<b>DART</b> AEROSPACE	
TITLE	
DWG NO. C60-18-6	
MAT'L	DRAWN BY: CANAM
1018/1020	APPROVED <i>D Weil</i>
UNLESS OTHERWISE SPECIFIED DIMENSIONS ARE IN INCHES	
.XXX ± .010	FRACTIONS ± 1/8
.XX ± .03	ANGLES ± 5°
.X ± .1	
1. BREAK ALL SHARP EDGES .015 x 45° OR .015R	
2. DIMENSIONAL LIMITS APPLY AFTER PLATING	
USED ON MODEL	
SCALE	1:1
DATE	2/16/2000
SHEET 1 OF 1

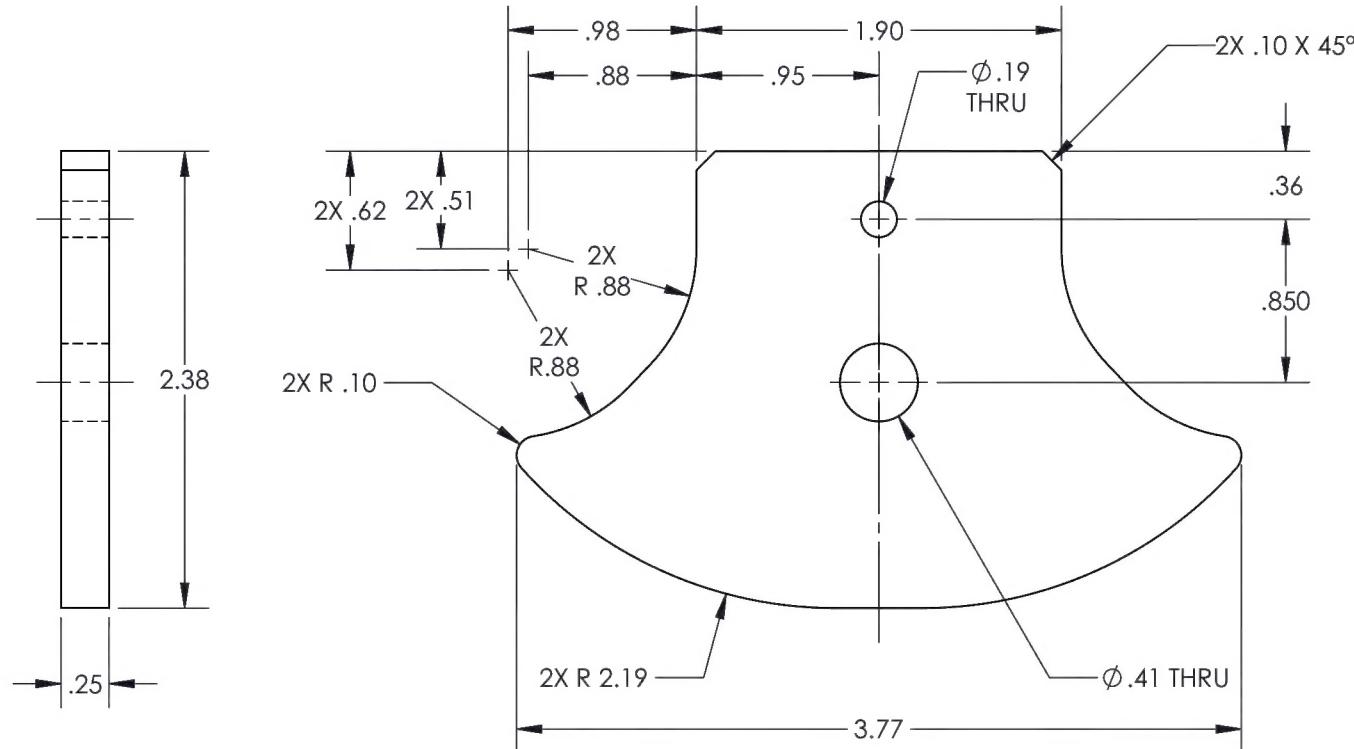
REVISIONS					
REV	ECR	DESCRIPTION	DATE	INITIAL	APPROVED
3		AS DRAWN BY CANAM.	11/7/2012	JAG	
4	15-0179	UPDATED TO NEW DRAFTING STANDARDS. CH'D DIMS WAS 1.04 IS .98, WAS 3.08 IS 1.90, WAS 1.54 IS .95, WAS 4.97 IS 3.77, WAS (.250) IS .25, WAS R2.27 IS 2X R2.19, WAS R.10 IS 2X R.10, WAS R.88 IS 2X R.88, WAS R.88 IS 2X R.88. ADDED DIMS 2X .51, 2X .62.	7/22/2015	DPD	JAG
